Access Compliance Report

Public Rights-of-Way

Intersection ID: 29684	Main Street: CAMERON_CREEK_DR	Cross Street: HAMPTON_GLEN_CT	Location: N
ADA ID: 20F97236BBD2	Ramp Type: PerpDiag	Initial Pass/Fail: Pass	Overall Compliance: No
			Severity Score: 15.25

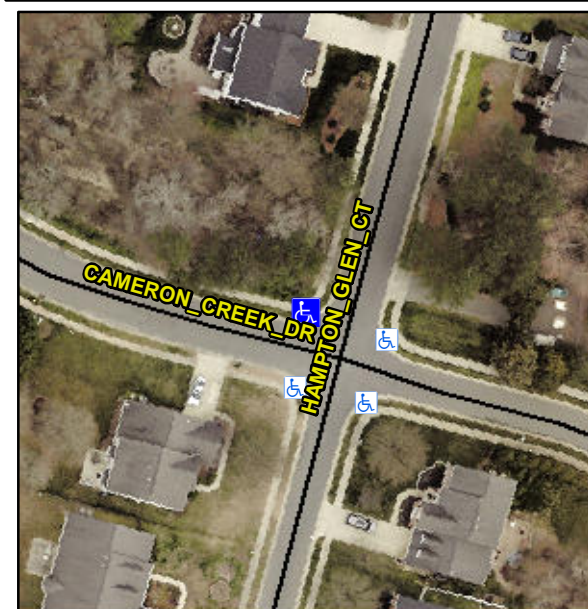
R304.5.3, R304.2.1, R304.2.2-Perp, R304.3.2-Para, R304.2.3, R305

Compliance	Description	Data	Compliance	Description	Data
N/A	Ramp Length (in)	50.5	Yes	Ramp Slope (%)	6.0
Yes	Ramp Width (in)	48.0	No	Ramp XSlope (%)	3.6
No	Flare Type	Curbed_WithWalkSurface	No	Flare Type RT	N/A
No	Flare Slope LT (%)	N/A	N/A	Flare Slope RT (%)	N/A
N/A	Flare Traversable LT?	No	N/A	Flare Traversable RT?	No
No	Landing Length (in)	44.0	No	DWS Provided?	No
Yes	Landing Width (in)	48.0	N/A	DWS Contrast?	No
No	Landing Slope (%)	4.3	N/A	DWS Length (in)	N/A
No	Landing X Slope (%)	6.6	N/A	DWS Full Width?	No
N/A	Landing Curb? (Y/N)	No	N/A	DWS Offset (in)	N/A
N/A	Shared Landing?	No			
Yes	Gutter Ponding?	No	Yes	Gutter Slope (%)	3.3
Yes	Gutter Lip Ht (in)	0.0	No	Gutter X Slope (%)	3.6
N/A	Painted X Walk1?	No	N/A	Painted X Walk2?	No
	X Walk 1 Direction	To SW		X Walk 2 Direction	To SE
N/A	X Walk 1 Width (in)	N/A	N/A	X Walk 2 Width (in)	N/A
	X Walk 1 Slope (%)	0.6		X Walk 2 Slope (%)	1.2
	X Walk 1 X Slope (%)	1.6		X Walk 2 X Slope (%)	2.8

N/A	Ramp inside XWalk1?	N/A	N/A	Ramp inside XWalk2?	N/A
	Road Slope (%)	2.4	N/A	Clear Space?	Yes
	Road X Slope (%)	1.1	N/A	Clear Space to XWalk (in)	N/A
Yes	Any Obstructions?	No	Yes	Storm Grate/Utility Hazard?	No
	Obstruction Type			Storm Grate/Utility Type	
		N/A			N/A
			Yes	Surface Condition? (G/P)	Good

Remove & Replace Curb Ramp With Two New Directional Ramps or Equivalent. Remove & Replace Gutter.
